Proposal for amendments to Regulation No. 67 (Equipment for liquefied petroleum gas (LPG))

I. Proposal

Figure 1
Angle between horizontal road surface and outlet plane of filling unit

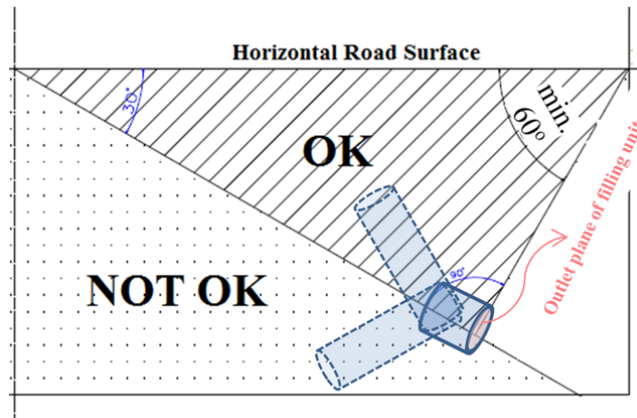
Insert a new paragraph 6.15.10.8., to read:

“6.15.10.8. Filling unit shall not be located at bottom surface of the vehicle. Center of outlet of filling unit shall be above 350 mm from the ground surface when vehicle is in its reference mass. In case the outlet of filling unit is located between 350 mm – 1200 mm above the ground, in vertical plane the angle between horizontal road surface and outlet plane of the filling unit shall be equal to or greater than 60 degrees if outlet is looking downwards.” (See Figure 1)

Justification for paragraph 6.15.10.8.:

There are no restrictions regarding the location of filling unit of LPG tank outside of the vehicle. Countries follow their national legislations.

In practice, the LPG tank filling unit located under the vehicle causes some problems, such as:

- Difficulty in filling the tank,
- Risks involved on occupational health and safety of LPG filling operators,
- Forces operators to kneel down or lie down on the ground in order to fill the tank,
- When the vehicle is in laden position, the filler pistol may be unable to fit the space between ground and filling unit and prevents the filling.

Item 4.18.1 of National AIM Regulation in Turkey regulates the filling unit location (for new modifications and manufacturing) in order to solve the above mentioned problems.

In this regard, it is proposed to add paragraph 6.15.10.8.
